- A. MerCruiser 250, 228TR, 330TR and 330TRS Transom Assembly Exhaust Tube
- B. MerCruiser I Drive Reverse Lock
- C. MerCruiser V-8 Engine Power Steering Dimension Change

A. MERCRUISER 250, 228TR, 330TR and 330TRS TRANSOM ASSEMBLY EXHAUST TUBE

Figure 1. Bellows and Tube Identification

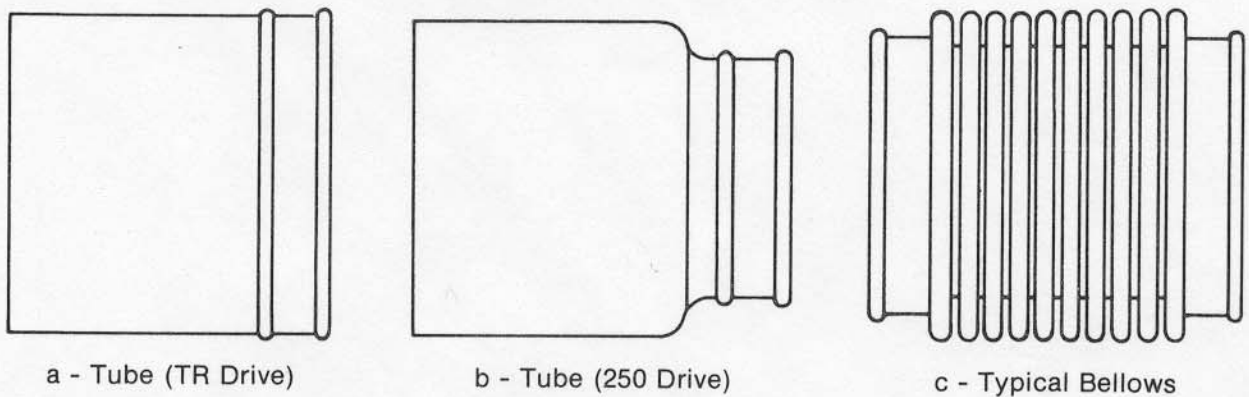
The above listed MerCruiser models in current production will have exhaust bellows replaced by new exhaust tubes. (See chart and Figure 1, following.)

Some TR transom assemblies have been produced with exhaust bellows installed. These transom cartons are marked to be used with 228TR's only. When servicing these 228TR transom assemblies, bellows may be replaced by the tube B-78632. It is mandatory that the tube (B-78632) and NOT the bellows (B-54406) be used on transom assemblies for the 250 and 330TR & TRS models. This is an essential product improvement that will improve engine and reverse thrust performance in engines above 228 HP. The exhaust tube is attached to the gimbal housing only, NOT to the bell housing.

Figure 2. Power Steering Dimension

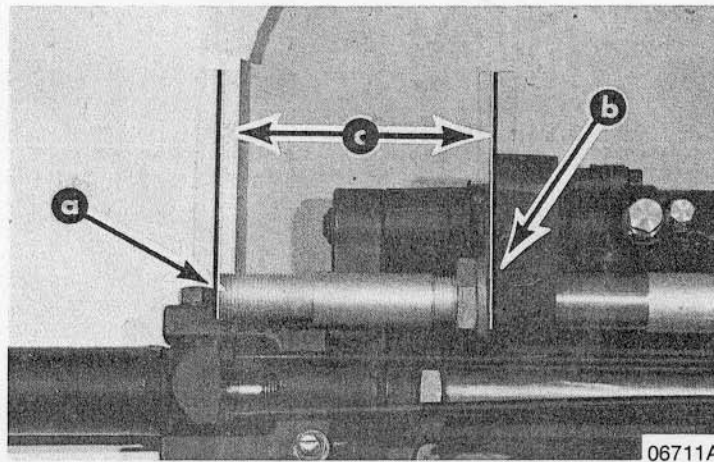
MerCruiser V-8 Engine Power Steering dimension (Figure 2) has been changed from $5\frac{1}{2}'' \pm \frac{1}{8}''$ to $6'' \pm \frac{1}{8}''$ ($13.97\text{cm} \pm 3.2\text{mm}$ to $15.24\text{cm} \pm 3.2\text{mm}$). This dimension change will affect the "MerCruiser 250 Stern Drive Installation Manual" (Page 5), "MerCruiser 228TR, 330TR and 330TRS Stern Drive Installation Manual" (Page 4) and "MerCruiser Service Manual" (Section 2 and Section 7). Make these changes in your manuals.
